HISTORIC AND DESIGN REVIEW COMMISSION

April 20, 2022

HDRC CASE NO: 2022-199
ADDRESS: 3903 N ST MARYS ST
LEGAL DESCRIPTION: NCB A52 BLK LOT P-2A
ZONING: R-6, H, RIO-3, PUBLIC PROPERTY
CITY COUNCIL DIST.: 2
LANDMARK: Individual Landmark
APPLICANT: Dale Austin/Sunland Group
OWNER: Ben Barton/San Antonio Zoo
TYPE OF WORK: Construction of a 1-story building
APPLICATION RECEIVED: April 01, 2022
60-DAY REVIEW: Not applicable due to City Council Emergency Orders
CASE MANAGER: Edward Hall

HDRC Project Overview for: San Antonio Zoo - 4D Ride City of San Antonio

ARCHITECTURAL SITE PLAN

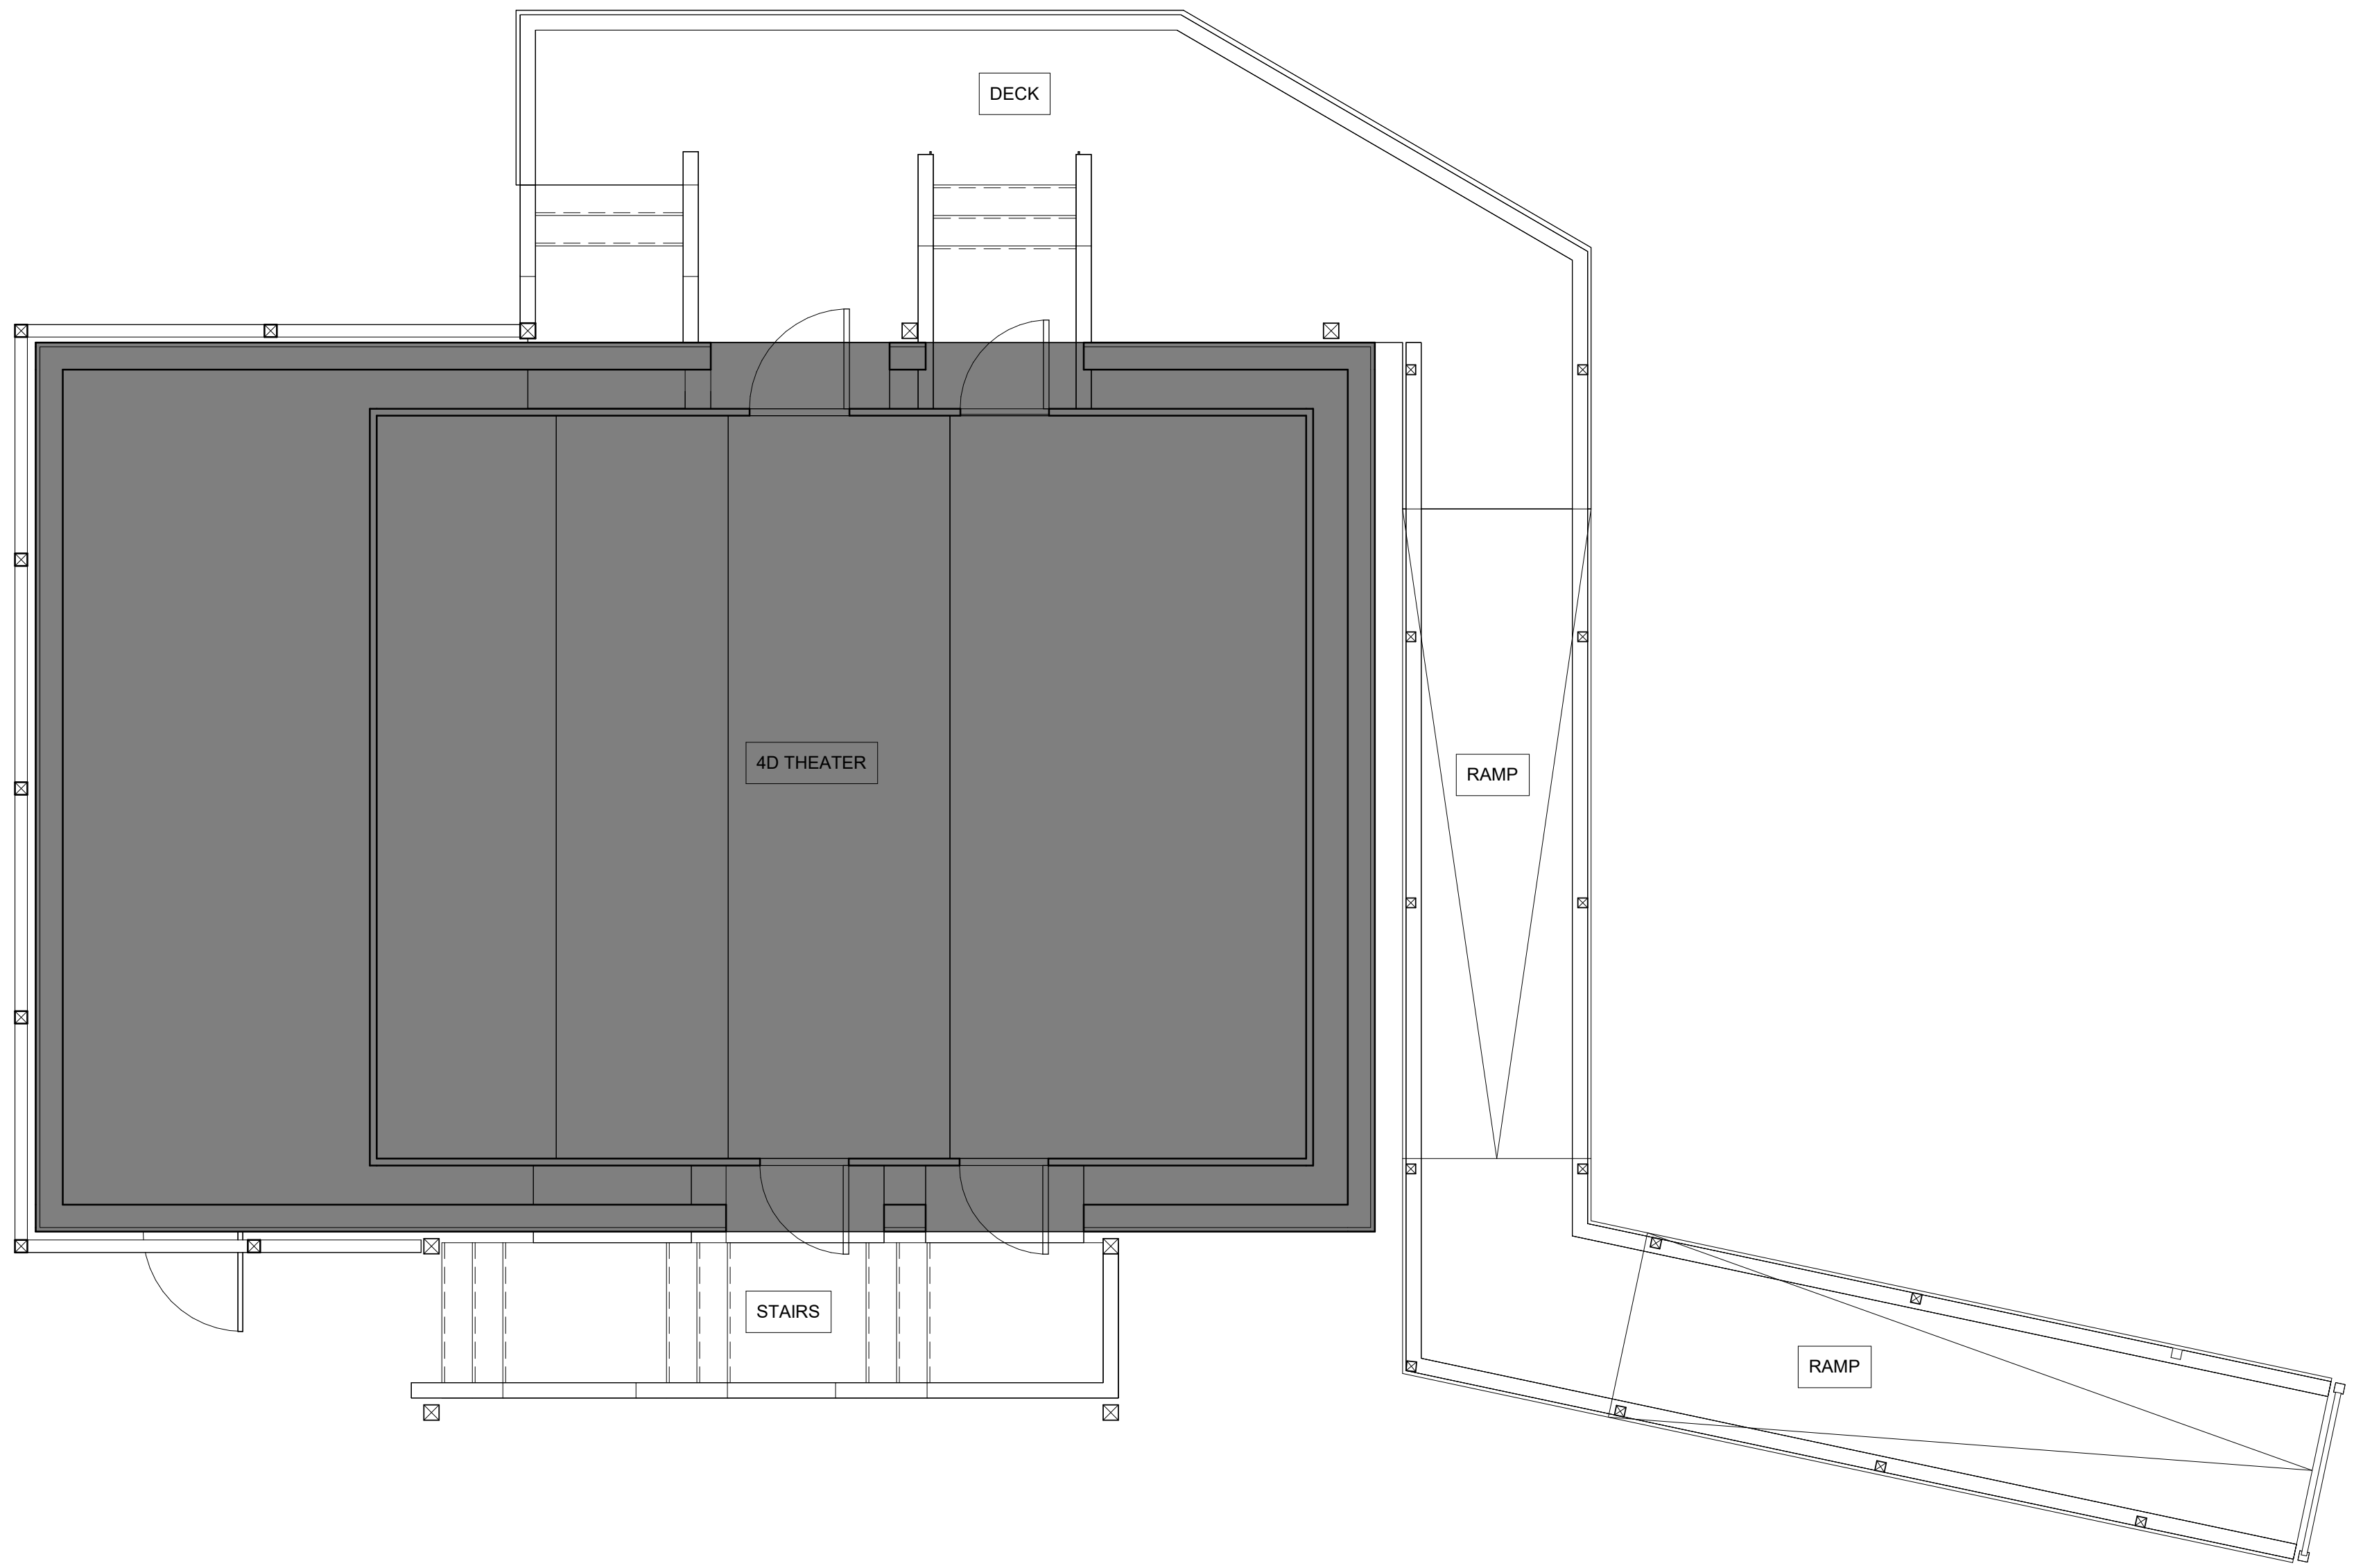
- b. LOCATION – The applicant has proposed to install the proposed prefabricated structures in a location that is currently paved with decomposed granite. No historic features or elements will be impacted through their installation. Additionally, the applicant has noted that an adjacent cypress tree will be preserved and protected.

- d. RAMP, DECK AND STAIRS – The applicant has proposed to install both a ramp and stairs to facilitate pedestrian access into the structure. Staff finds both to be appropriate.

PERSPECTIVES

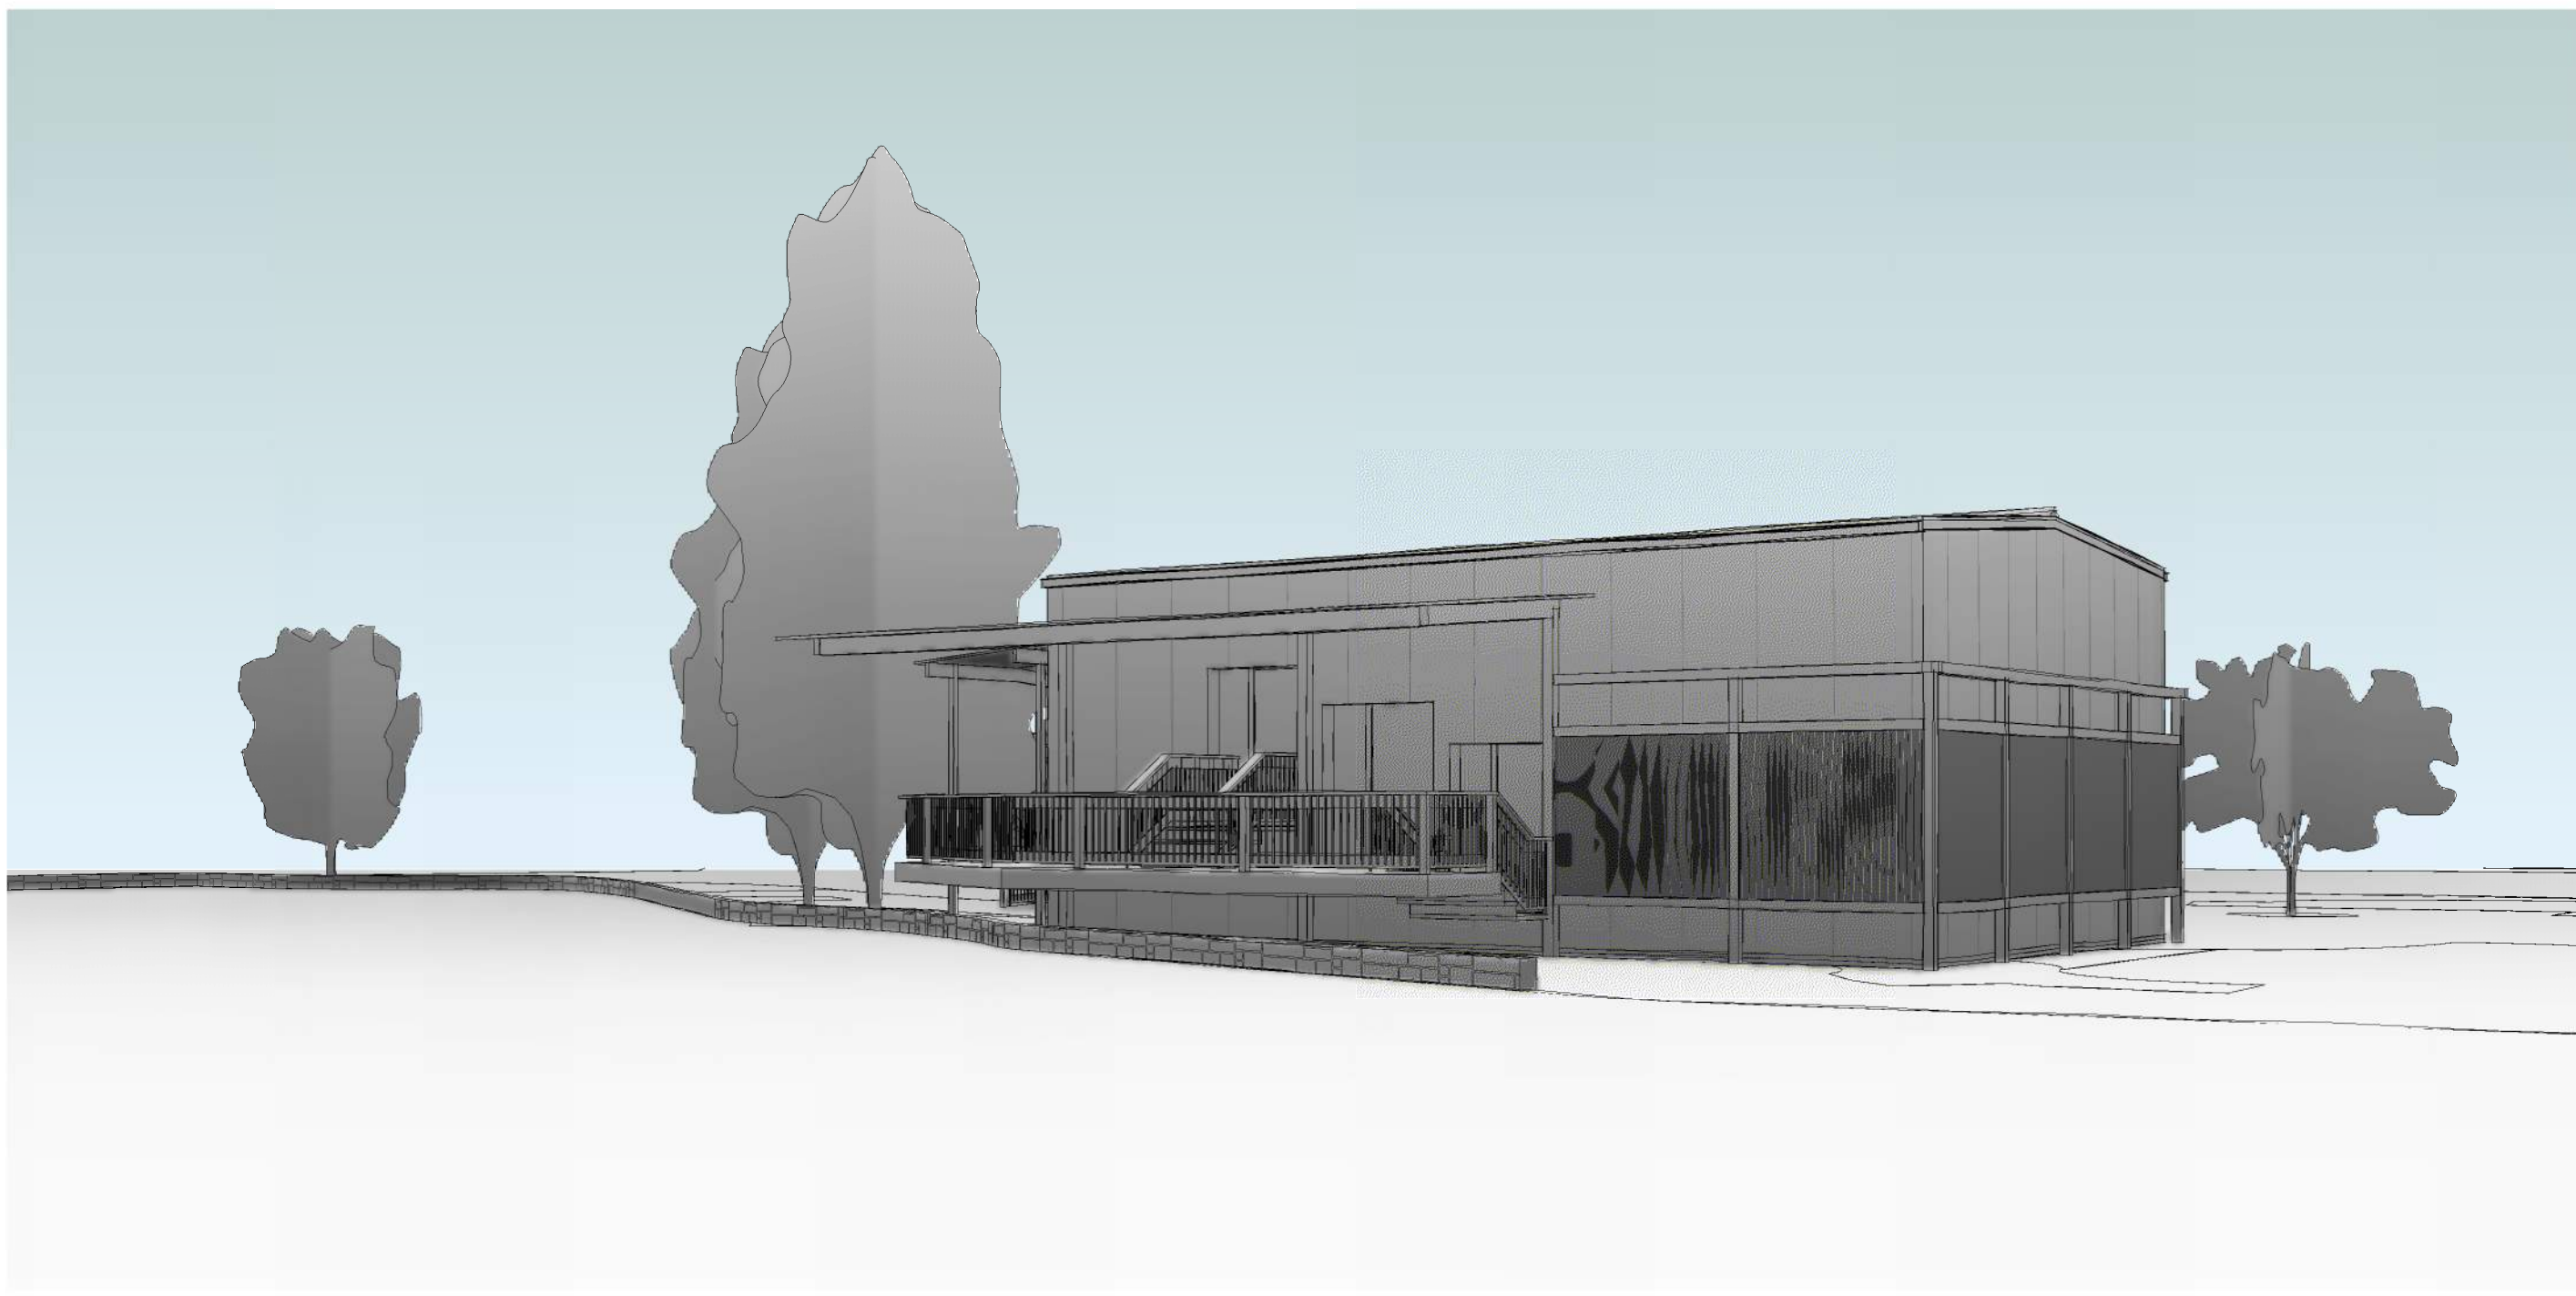
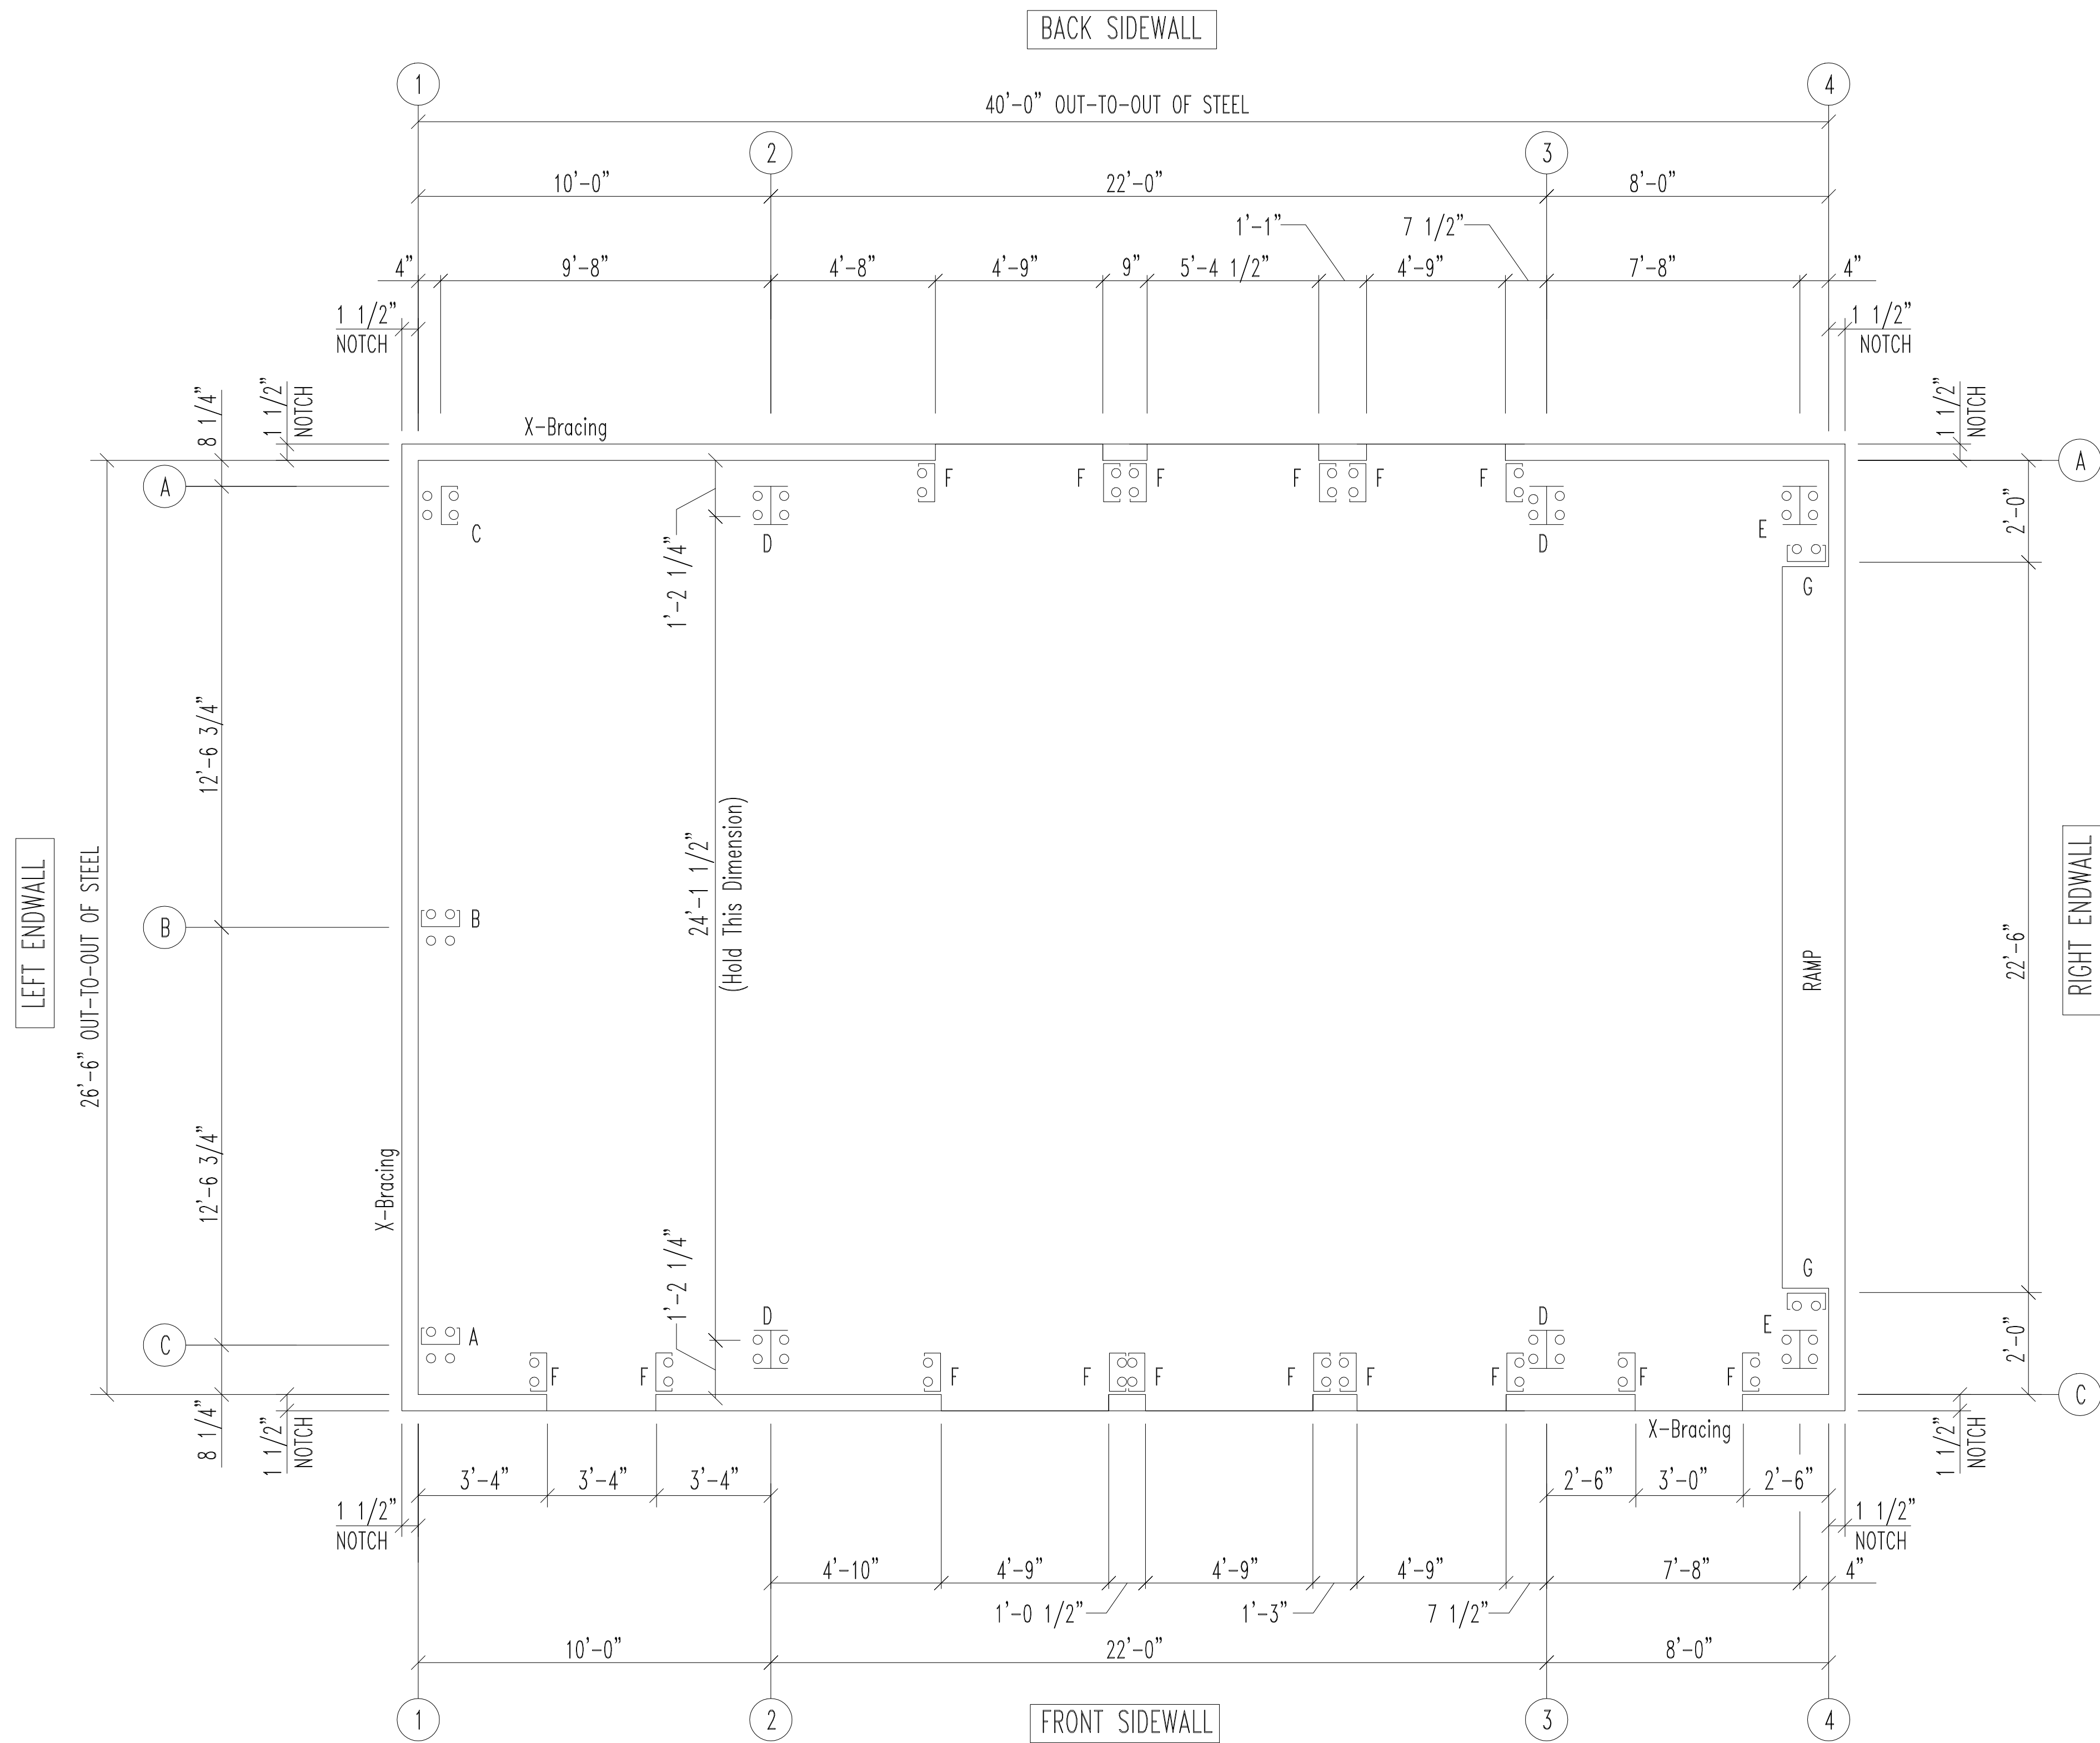
- c. PREFABRICATED STRUCTURES – The applicant has proposed to install two prefabricated structures that will be connected and enclosed within prefabricated metal building. The proposed exterior structure will feature a gabled roof with a 1/12 slope, brown metal panels, and a metal roof. Generally, staff finds the proposed materials to be appropriate. In addition to the enclosed structure, the applicant has proposed two side canopies. Staff finds the design and installation of these to be appropriate.

- e. SIGNAGE – The applicant has noted the installation of two signage panels and one marquee sign. Staff generally finds the location of each to be appropriate; however, staff finds that final signage details should be submitted to OHP staff for review and approval. Signage should be indirectly lit.
